Please find my letter of Objection to **Application# DA2020/0572**
Lot 1 DP 22361 2A Ruskin Rowe Avalon Beach

Re Application# DA2020/0572

Lot 1 DP 22361 2A Ruskin Rowe Avalon Beach — in response to the Northern Beaches Council Planner, Phil Lane's letter of 3 June 2020.

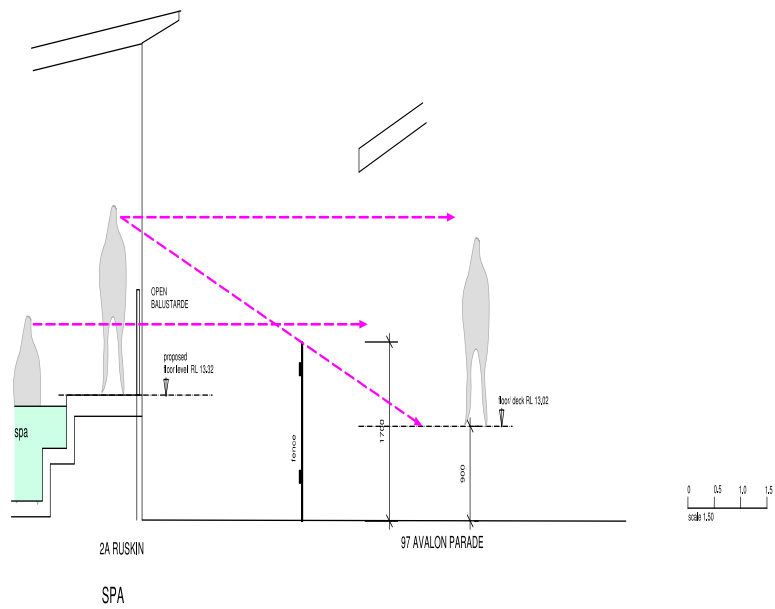
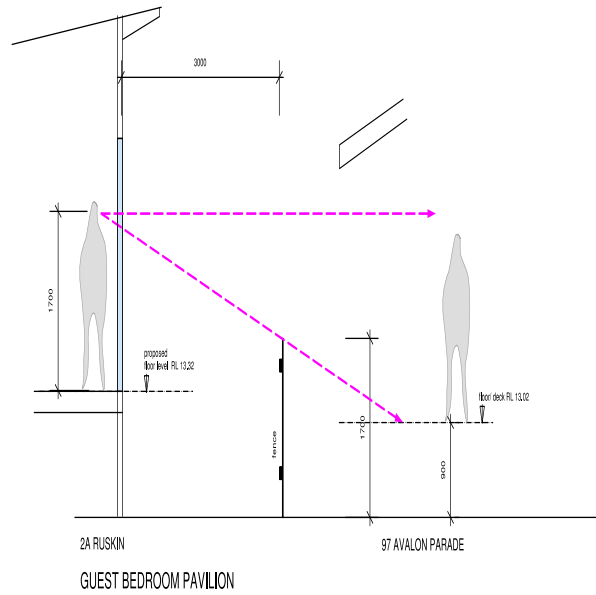
Of all these elements it is the three bed/two bathroom + open spa labelled 'Guest Accommodation Pavilion' that is totally unacceptable to us on the grounds of: **loss of visual and acoustic privacy** from all proposed rooms. See full height glass windows/doors in N (actually NW) elevation.

Loss of acoustic privacy particularly from the spa that is open and just 3 m from common boundary.

The Application argues that a 'landscaped courtyard' (3m x 20m) will solve the potential loss of our long-standing amenity. There is NO landscape plan for this area. Further: vegetation, whatever the species or height, offers almost zero acoustic attenuation.

Possible Solution: take the 'Guest Accommodation' pavilion and flip the plan around its long axis. Consequences: Now the 'guests' can participate in on-site activities — their bedroom windows will face the centre of the new development.

We would then accept the blank wall (of the reversal) that is similar to the gymnasium. Visual and acoustic privacy solved!
